Our Ref: 24004 OW Resubmission 2 12 and 14 Murphy Street

OPERATIONAL WORKS RESUBMISSION (OP 2024_5601/1) – CHANGE APPLICATION

12 and 14 MURPHY STREET, PORT DOUGLAS (L113 PTD2094 & L114 PTD2094)

| Subject | Site Access Road Safety Assessment |

STATUS
FOR INFORMATION
SCALE (AT FULL SIZE)
1:150
DRAWING NUMBER
24004-SK003
SIZE
A1
REVISION
A

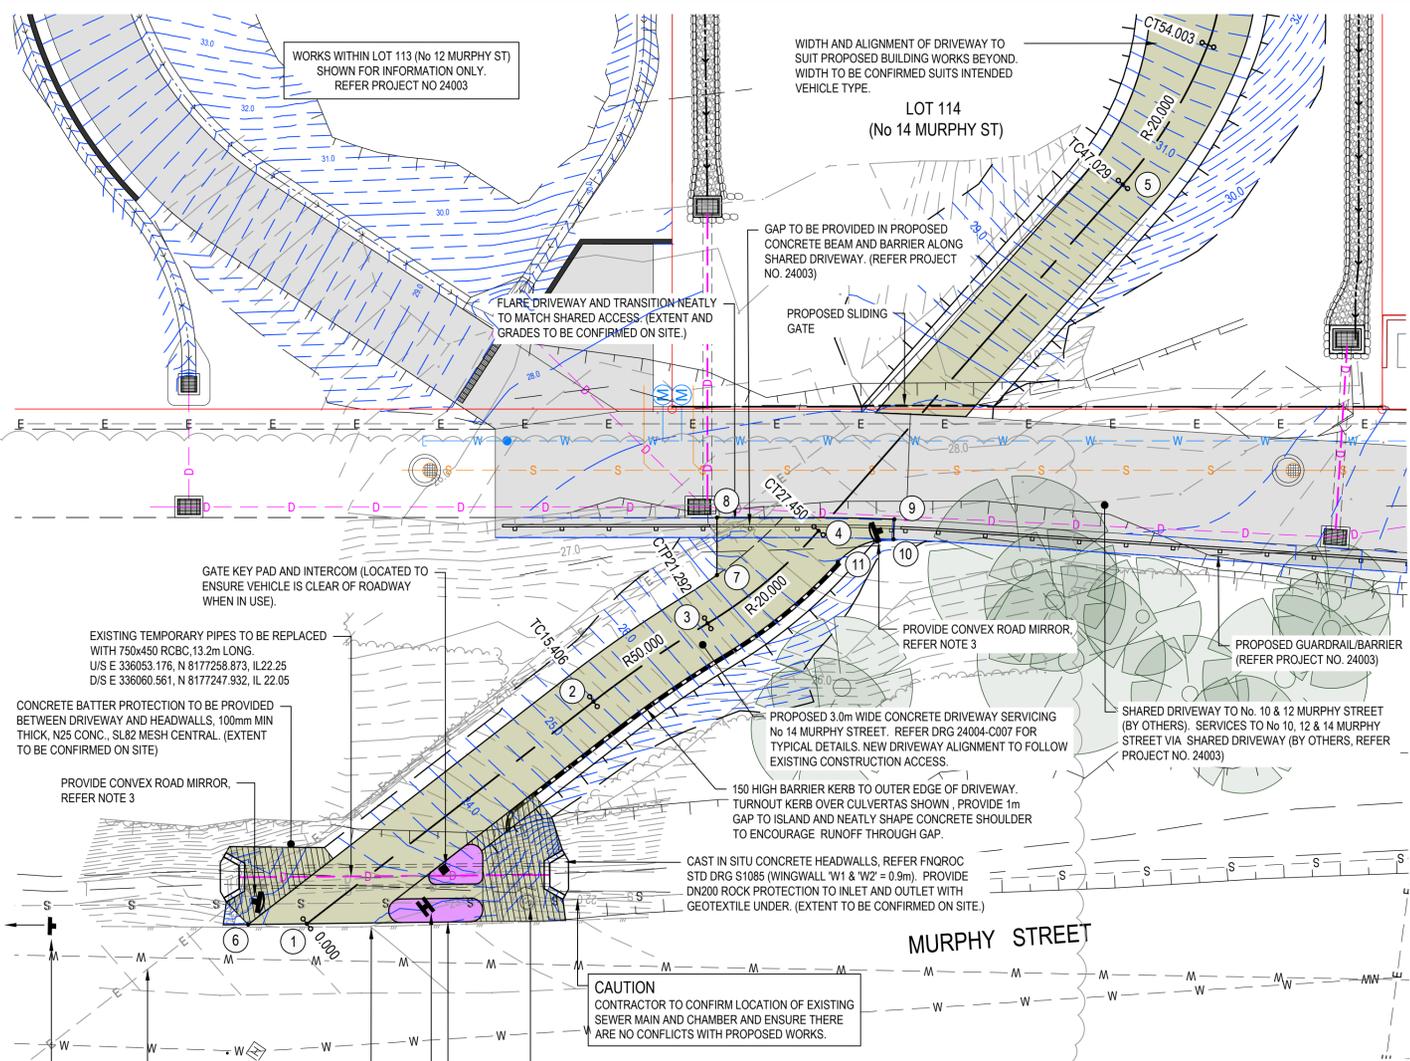
| Item | Issue Description | Recommendation | Compliance |
|------|--|---|--|
| 3 | It is unclear from the development plans if a swept path assessment was undertaken at the site access intersection with Murphy Street as part of the approved construction access. The proposed alignment may impact on usability of the proposed private connection | Undertake a swept path assessment to confirm accessibility in accordance with AS2890.1. Confirm how vehicles will exit the driveway if they cannot open the security gate. | Complies. Swept path review undertaken. Signage added with call point at entrance to allow easy exit maneuver. |

| 5 | It is unclear if appropriate sight distances are provided at the access point to Murphy Street. This issue may be worsened during dark conditions. | Confirm that sight distances accord with Austroads Guide to Road Design and/or the Australian Standards (2890.1). Where possible, maintain planting located within the verge to increase sight distances. Where sight distances can't be achieved, provide advanced warning signage of approaching property access points. | Complies. Sight distances checked. 24004 SK003(A) shows line of sight compliance Concealed Driveways advisory sign also added. |
| 6 | It is unclear if appropriate sight distances are provided at the driveway intersection between 12 and 14 Murphy Street. While traffic volumes are likely to be less when the access operates as a private driveway compared to the approved construction issue, the issue maybe worsened during dark conditions. | Provide appropriate signage advising residents approaching the driveway of the conflict point. Provide signage requiring vehicles entering and exiting 12 Murphy Street to Stop or Give way to vehicles approaching or departing 14 Murphy Street. Ensure that sight distances at the intersection enable approaching vehicles to see each other in accordance with AS2890.1. Where possible, maintain planting located within the verge to increase sight distances. Where sight distances can't be achieved, provide convex mirrors to increase driveway awareness of approaching vehicles. | Complies. Private driveway sign added to detract non-resident use. Left tun only exit sign added. Convex mirrors added to provide line of sight for 12 Murphy Street driveway and also at Murphy Street exit. Note: Sight distance is adequate at Murphy Street exit but the angle (over the shoulder) is too steep – the convex mirror overcomes this issue. |
| 7 | Development plans include an intercom for vehicles entering the new connection to 14 Murphy Street. However, the gradients on the new driveway are steep which may be safety hazard for drivers approaching the intercom, including visitors. | Utilise remote control access for the security gate. Investigate the potential to locate the intercom on the flat section of the access to ensure that queueing and control point gradients accord with AS2890.1 requirements. This may require relocation of the security gate. Confirm how vehicles will exit the driveway if they cannot open the security gate. | Complies. Remote access provided and located at entrance off Murphy Street to allow easy exiting if required. Access point placed sufficiently forward to ensure B99 vehicle clears Murphy Street pavement. |

STOPPING SIGHT DISTANCE
(AS 2890.1)
V=40km/hr / SSD =30m

GATE KEY PAD AND INTERCOM (LOCATED TO ENSURE VEHICLE IS CLEAR OF ROADWAY WHEN IN USE)

SIGNS TO BE MOUNTED ON SAME POLE
RIGHT TURN ONLY SIGN TO BE FACING EXITING TRAFFIC.
PRIVATE DRIVEWAY SIGN (INDICATIVE DETAILS SHOWN)
TO BE FACING ENTERING TRAFFIC.

DRAWING NUMBER: **24004-C012** REVISION: **C**

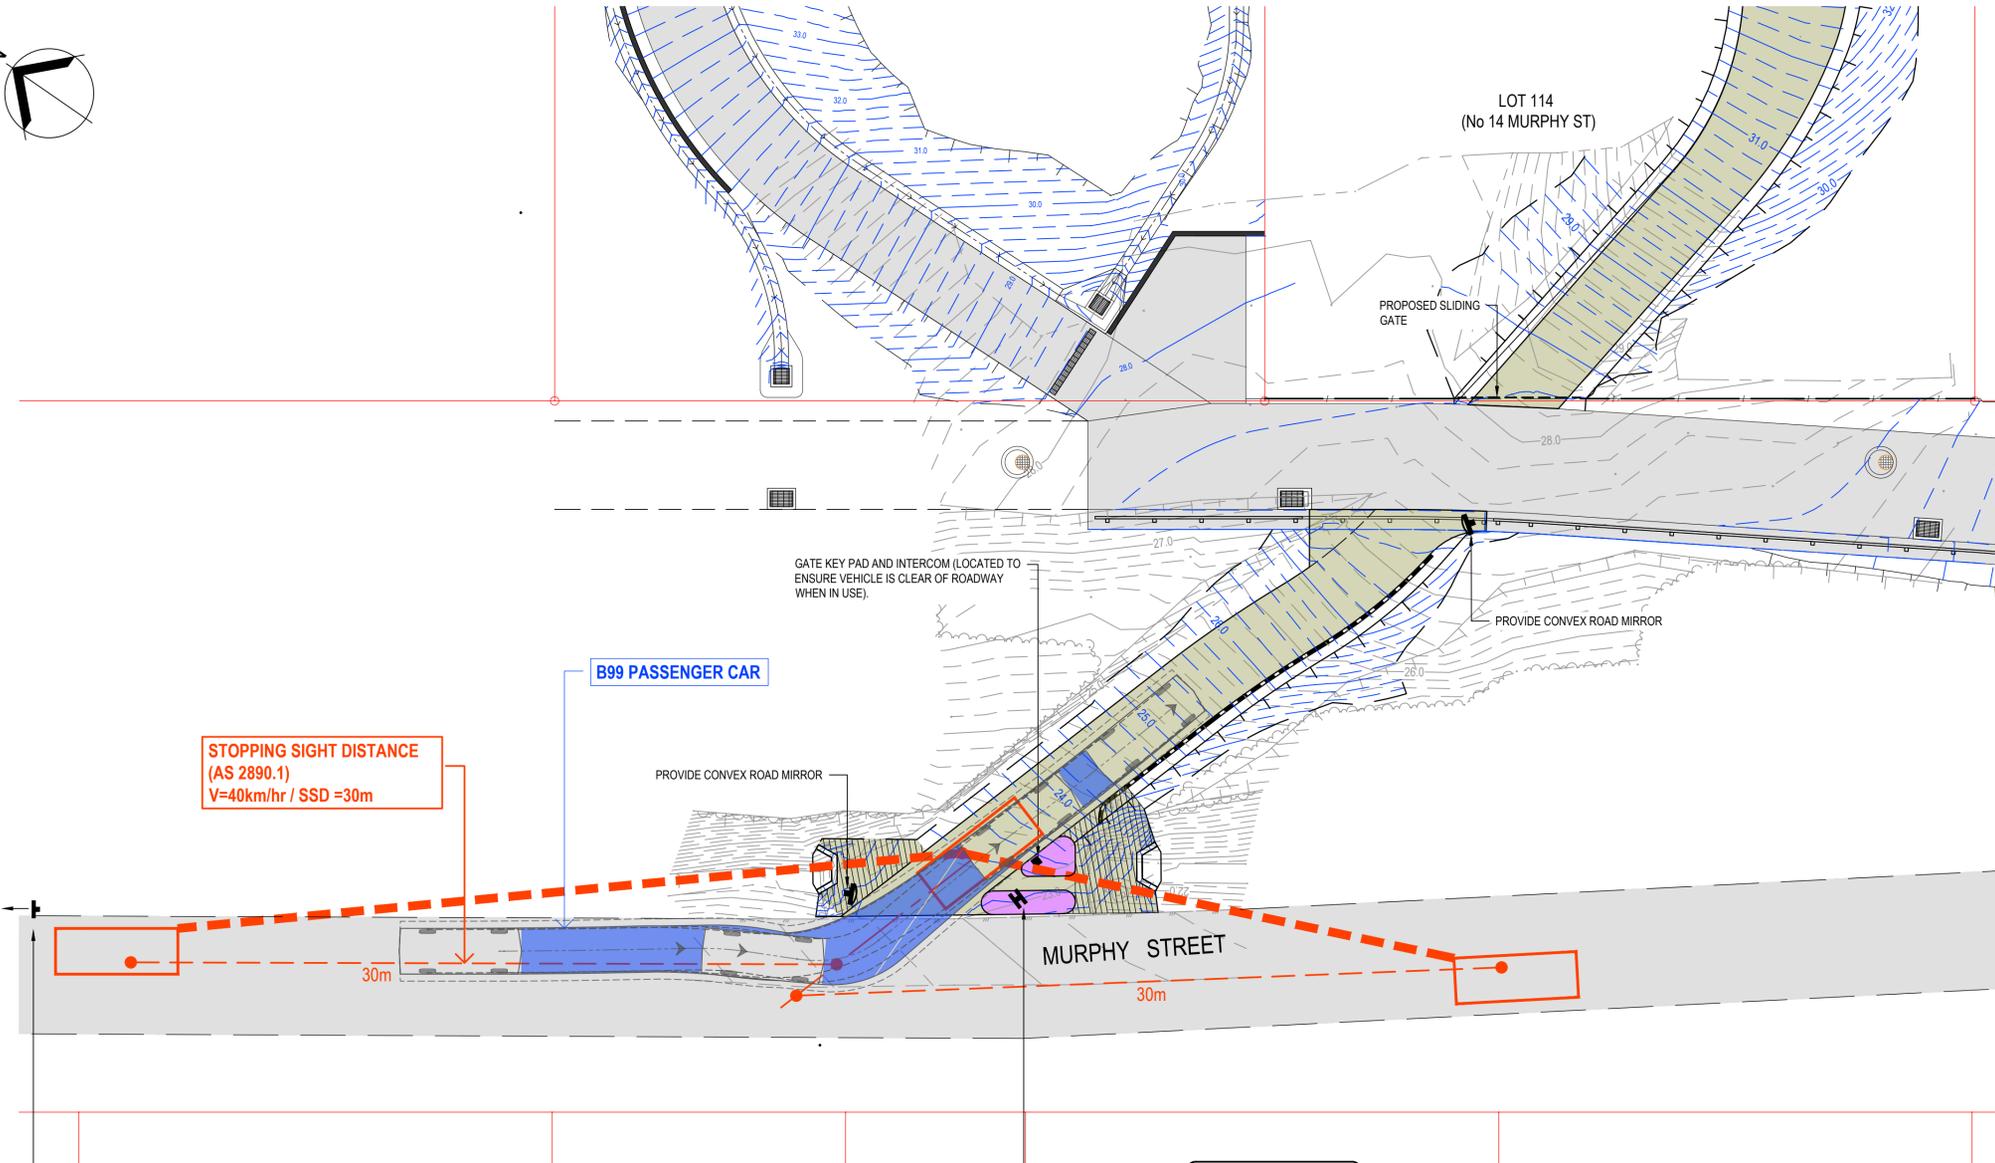
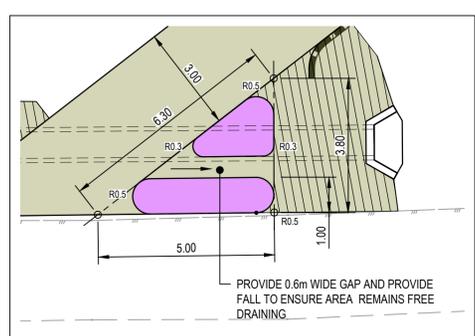
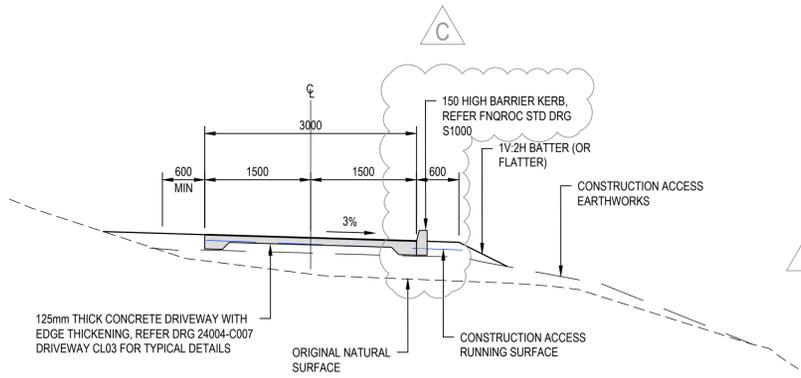
- a. include concrete batters tying the headwalls in;
- b. include a sewer manhole riser inhibiting stormwater from flowing into the manhole lid;
- c. be designed in accordance with the generic design standards of the FNQROC Development Manual standard drawing S1105G;

| Item | Issue Description | Recommendation | Compliance |
|------|--|---|--|
| 1 | A review of aerial imagery and street view indicates that a crest is located to the north-west of the site access point which may result in incidents between vehicles on Murphy Street and vehicles exiting the site. | Install driveways beyond crest signage on Murphy Street to advise drivers travelling eastbound on Murphy Street of the approaching driveways (existing and proposed). | Complies. Concealed Driveways advisory sign added as recommended. |
| 2 | A crest is located on Murphy Street to the north-west of the site. Vehicles travelling over the crest may not expect a vehicle to slow down to turn left into the site access which may result in rear end type incidents. | Install driveways beyond crest signage on Murphy Street to advise drivers travelling eastbound on Murphy Street of the approaching driveways (existing and proposed). | Complies. Concealed Driveways advisory sign added as recommended. |

| 5 | The batter slope grades adjacent to the new access are unclear. The potential exists for errant vehicles to leave the driveway. | Confirm the batter slopes accord with Austroads Guide to Road design or similar. Where necessary, install a barrier or kerb to prevent errant vehicles from leaving the driveway. | Complies. Batters are 1:2 max with planting for stability and erosion control. Kerb also included to demarcate edge and direct flows to concreted batter. |

Please find attached plan 24002 C012(C) which has been amended to include items a, b and c above.

| REV | DESCRIPTION | DRN | APP | DATE |
|-----|---|-----|-----|----------|
| C | KERB, SIGNS AND MIRRORS ADDED, ISLAND AMENDED | GB | GA | 21/01/25 |

'CONCEALED DRIVEWAYS' SIGN TO BE LOCATED WITHIN MURPHY STREET VERGE IMMEDIATELY TO THE WEST OF ISLAND POINT ROAD INTERSECTION. EXACT LOCATION TO BE CONFIRMED WITH COUNCIL ON SITE.

PROVIDE CONVEX ROAD MIRROR

PROVIDE CONVEX ROAD MIRROR

Figure 1.1 Proposed Site Access Layout

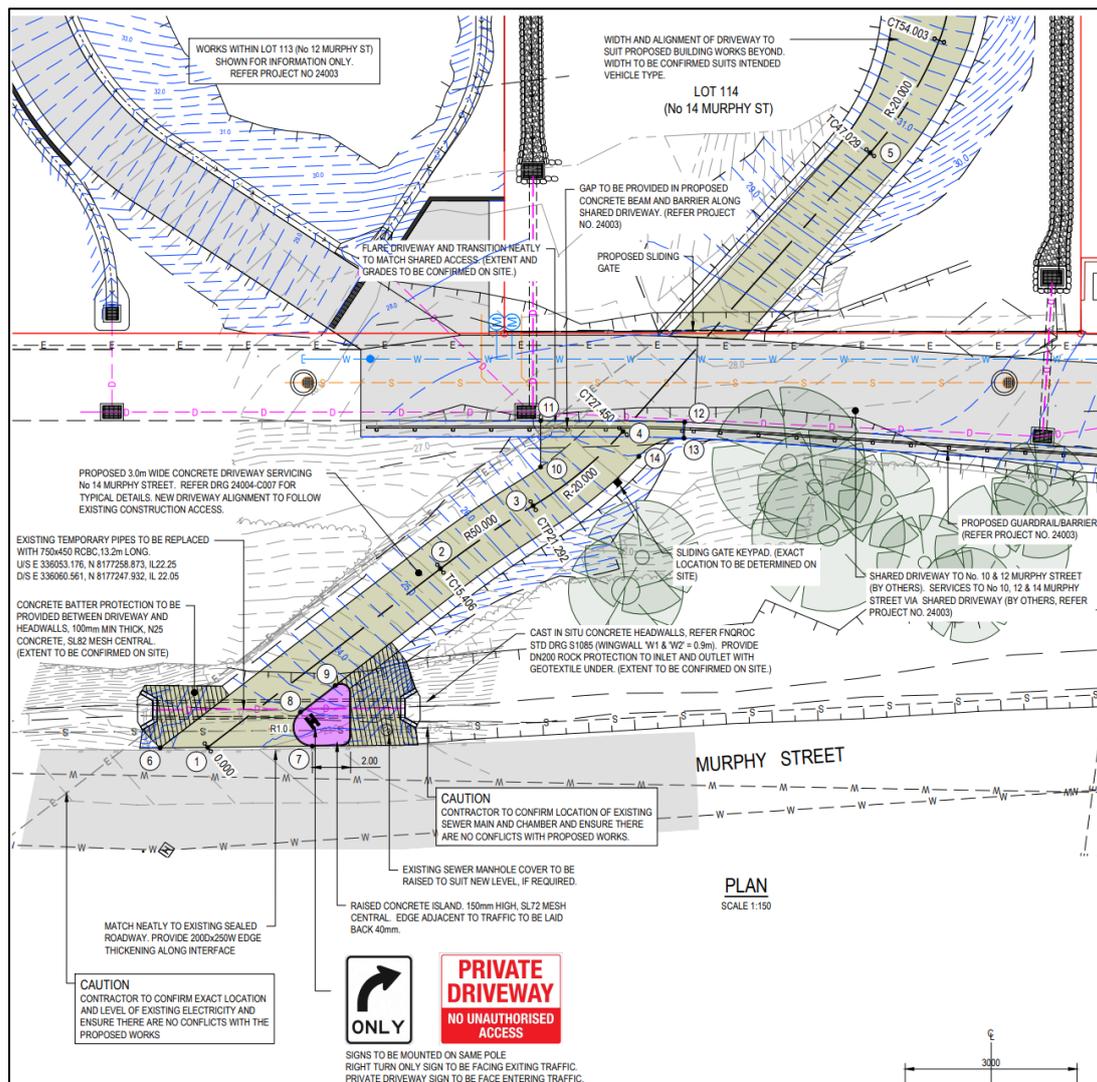
| Item | Issue Description | Without Development (Approved Construction Access only) | | | With Development (private driveway) | | | Recommendation | Residual Risk | | |
|------|--|---|---|------|-------------------------------------|---|------|---|---------------|---|------|
| 1 | A review of aerial imagery and street view indicates that a crest is located to the north-west of the site access point which may result in incidents between vehicles on Murphy Street and vehicles exiting the site. | 2 | 3 | M | 2 | 3 | M | <ul style="list-style-type: none"> ➤ Install driveways beyond crest signage on Murphy Street to advise drivers travelling eastbound on Murphy Street of the approaching driveways (existing and proposed). | 1 | 3 | L |
| 2 | A crest is located on Murphy Street to the north-west of the site. Vehicles travelling over the crest may not expect a vehicle to slow down to turn left into the site access which may result in rear end type incidents. | 2 | 3 | M | 2 | 3 | M | <ul style="list-style-type: none"> ➤ Install driveways beyond crest signage on Murphy Street to advise drivers travelling eastbound on Murphy Street of the approaching driveways (existing and proposed). | 1 | 3 | L |
| 3 | It is unclear from the development plans if a swept path assessment was undertaken at the site access intersection with Murphy Street as part of the approved construction access. The proposed alignment may impact on usability of the proposed private connection | 1 | 3 | L | 1 | 3 | L | <ul style="list-style-type: none"> ➤ Undertake a swept path assessment to confirm accessibility in accordance with AS2890.1. ➤ Confirm how vehicles will exit the driveway if they can not open the security gate. | 1 | 2 | L |
| 4 | It is unclear from development plans how pedestrian access is provided to the subject site with the approved construction access and/or the proposed residential access. | 1 | 4 | M | 1 | 4 | M | <ul style="list-style-type: none"> ➤ Clarify how pedestrians will access the site. ➤ Ensure that pedestrian access arrangements accord with Council's Planning Scheme or appropriate design guidelines as required. | 1 | 3 | L |

| Item | Issue Description | Without Development (Approved Construction Access only) | | | With Development (private driveway) | | | Recommendation | Residual Risk | | |
|------|---|---|---|------|-------------------------------------|---|------|---|---------------|---|------|
| 5 | The batter slope grades adjacent to the new access are unclear. The potential exists for errant vehicles to leave the driveway. | 1 | 3 | L | 2 | 3 | M | <ul style="list-style-type: none"> ➤ Confirm the batter slopes accord with Austroads Guide to Road design or similar. ➤ Where necessary install a barrier or kerb to prevent errant vehicles from leaving the driveway. | 1 | 3 | L |
| 5 | It is unclear if appropriate sight distances are provided at the access point to Murphy Street. This issue may be worsened during dark conditions. | 1 | 3 | L | 2 | 3 | M | <ul style="list-style-type: none"> ➤ Confirm that sight distances accord with Austroads Guide to Road Design and/or the Australian Standards (2890.1). ➤ Where possible, maintain planting located within the verge to increase sight distances. ➤ Where sight distances can't be achieved, provide advanced warning signage of approaching property access points. | 1 | 2 | L |
| 6 | It is unclear if appropriate sight distances are provided at the driveway intersection between 12 and 14 Murphy Street. While traffic volumes are likely to be less when the access operates as a private driveway compared to the approved construction issue, the issue may be worsened during dark conditions. | 2 | 3 | M | 2 | 3 | M | <ul style="list-style-type: none"> ➤ Provide appropriate signage advising residents approaching the driveway of the conflict point. ➤ Provide signage requiring vehicles entering and exiting 12 Murphy Street to Stop or Give way to vehicles approaching or departing 14 Murphy Street. ➤ Ensure that sight distances at the intersection enable approaching vehicles to see each other in accordance with AS2890.1. ➤ Where possible, maintain planting located within the verge to increase sight distances. ➤ Where sight distances can't be achieved, provide convex mirrors to increase driveway awareness of approaching vehicles. | 1 | 3 | L |

| Item | Issue Description | Without Development (Approved Construction Access only) | | | With Development (private driveway) | | | Recommendation | Residual Risk | | |
|------|---|---|----|------|-------------------------------------|---|------|---|---------------|---|------|
| 7 | Development plans include an intercom for vehicles entering the new connection to 14 Murphy Street. However, the gradients on the new driveway are steep which may be safety hazard for drivers approaching the intercom, including visitors. | NA | NA | NA | 2 | 4 | M | <ul style="list-style-type: none"> ➤ Utilise remote control access for the security gate. ➤ Investigate the potential to locate the intercom on the flat section of the access to ensure that queueing and control point gradients accord with AS2890.1 requirements. This may require relocation of the security gate. ➤ Confirm how vehicles will exit the driveway if they cannot open the security gate. | 1 | 4 | M |
